Subject: Dresden Station Units 2 and 3  
Quad Cities Station Units 1 and 2  
Additional Response Concerning  
IE Bulletin 79-14  
NRC Docket Nos. 50-237/249  
and 50-254/265

Quad Cities Nuclear Station - Units 1 and 2  
Dresden Nuclear Station - Units 2 and 3

Response to NRC Questions on the August, 1989,  
Piping System Operability Criteria Licensing Submittal

FIG. 4-3. Comparison of Housner design response spectra and response spectrum for El Centro earthquake, 5/18/40 N-S component (Source: Refs. 7 and 10).

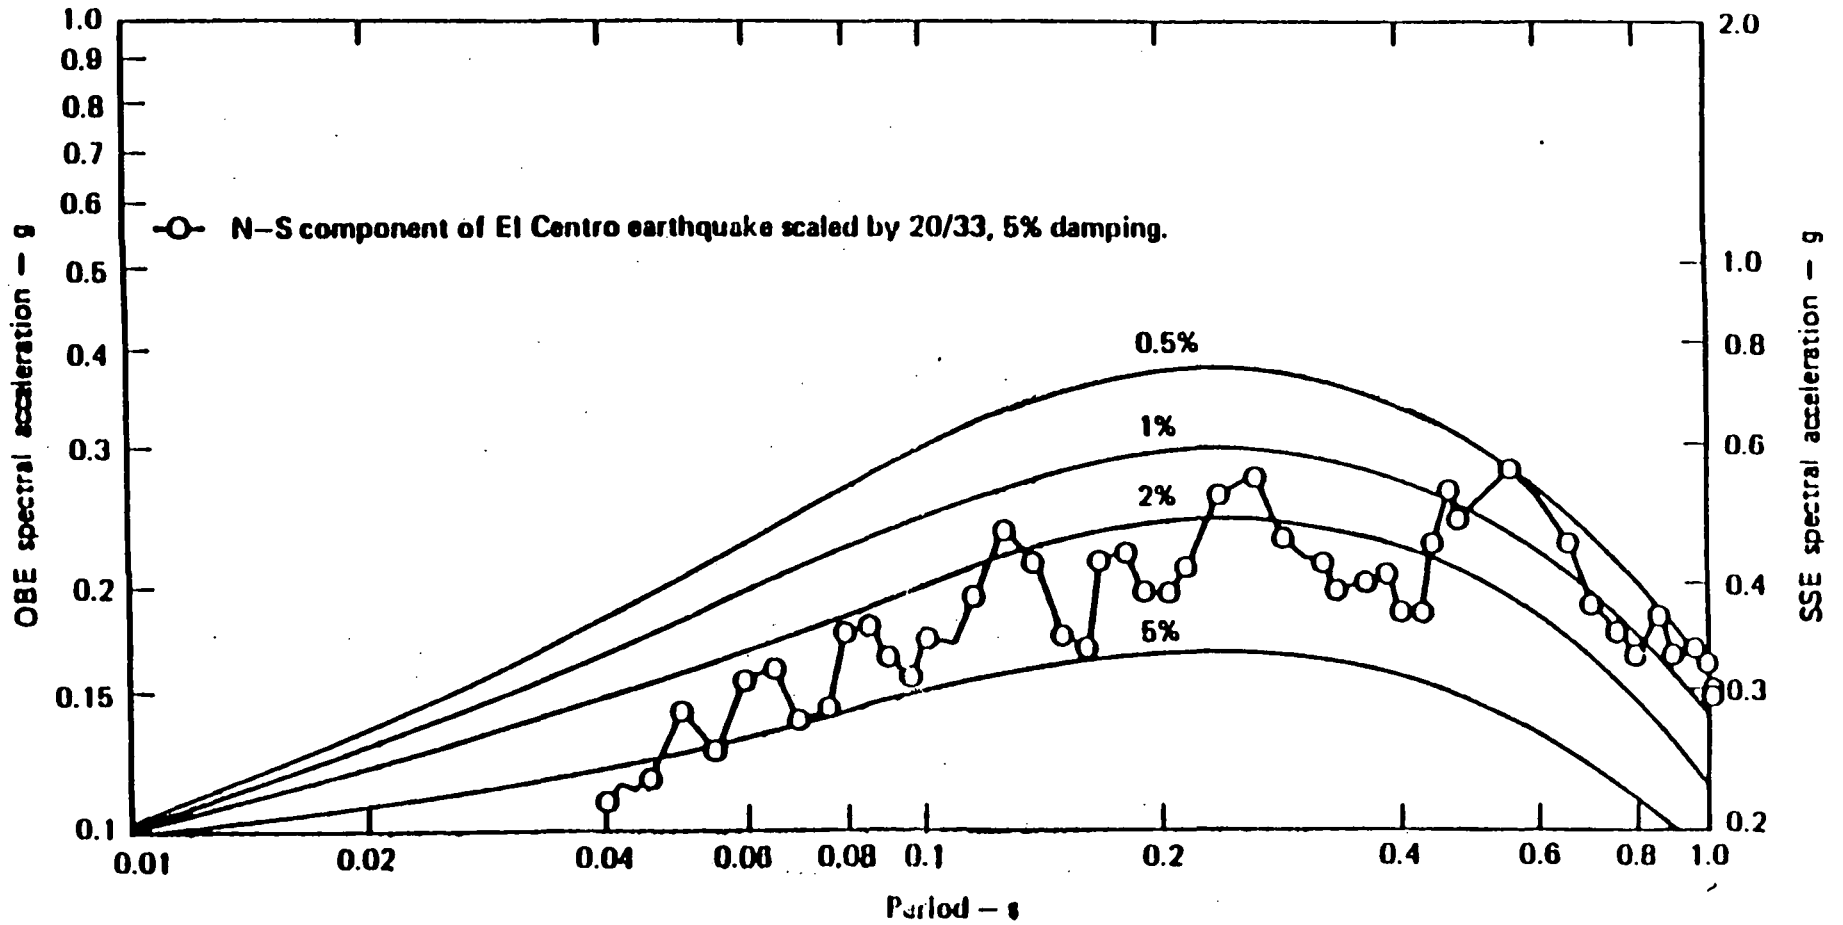
- c. As noted in NUREG/CR-0891, "Seismic Review of Dresden Nuclear Power Station - Unit 2, For The Systematic Evaluation Program," [7] there was considerable margin between the response spectrum from the El Centro time history and the Housner design response spectrum (see Figure 4-3, attached) for periods above about .05 sec. The time history was used in the analysis of the reactor-turbine building.

SEISMIC SPECTRA - OBE

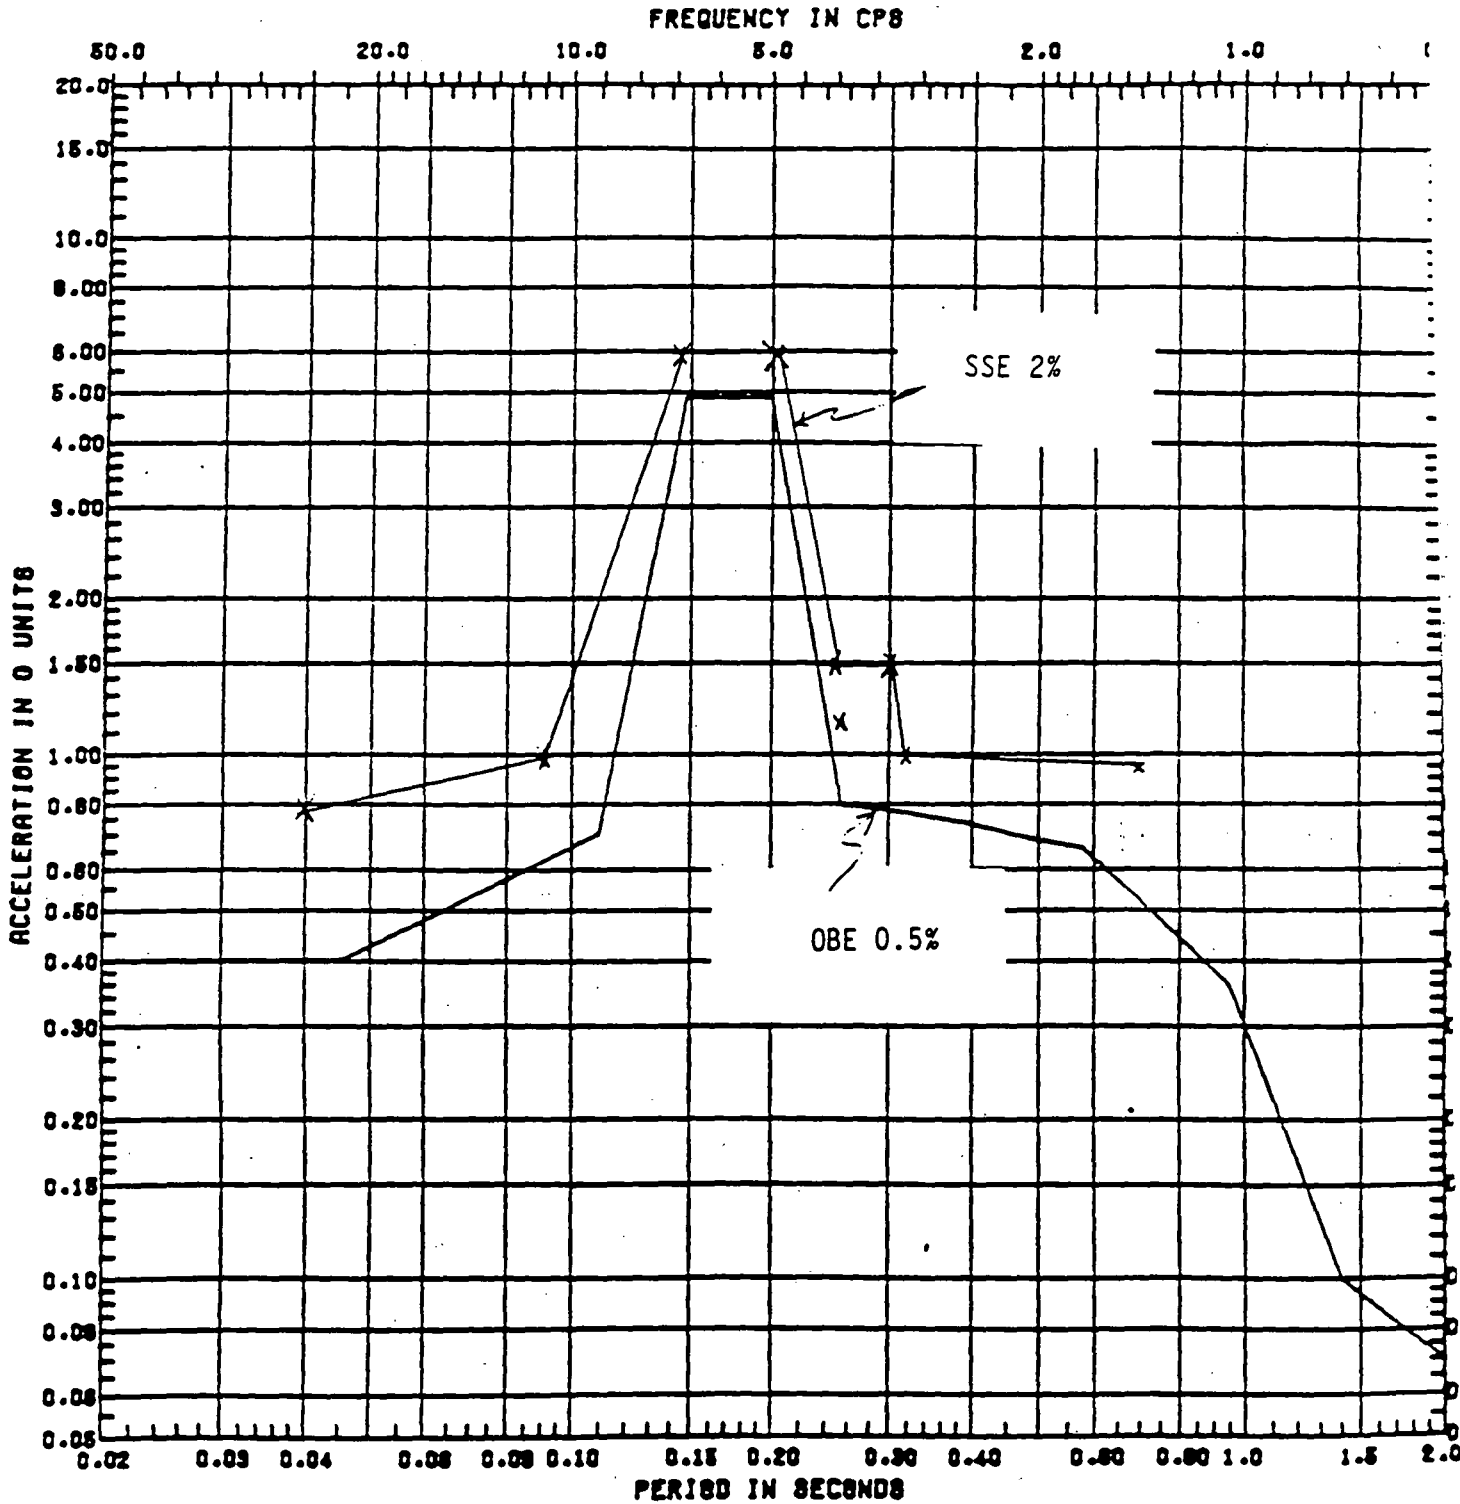
- 2.3 The criteria does not provide pipe stress limits for operating basis earthquake (OBE) and other occasional loads including waterhammer or steamhammer. These limits should be defined and if they exceed Code allowables, the actions that would be taken to assure continued operability should be explained. (Section 3.1)

The operability criteria does not provide pipe stress limits for OBE since limiting sustained plus SSE pipe stresses to  $2S_y$  already ensures piping system operability and that safe shutdown can occur. This is because the SSE response spectra (at 2% damping) always envelopes the OBE response spectra (at 1% damping). The primary reason that SSE always envelopes OBE at their corresponding Regulatory Guide 1.61 damping values is that SSE originally was defined as twice OBE without allowance for the higher structural damping during as SSE (see response to question 2.1). As a further demonstration of this fact, the attached page A-12 from the Dresden Seismic Design Document has been marked-up to compare SSE at 2% damping to OBE at 0.5% damping. In this example, the SSE response spectra even envelopes the OBE response spectra at 0.5%.
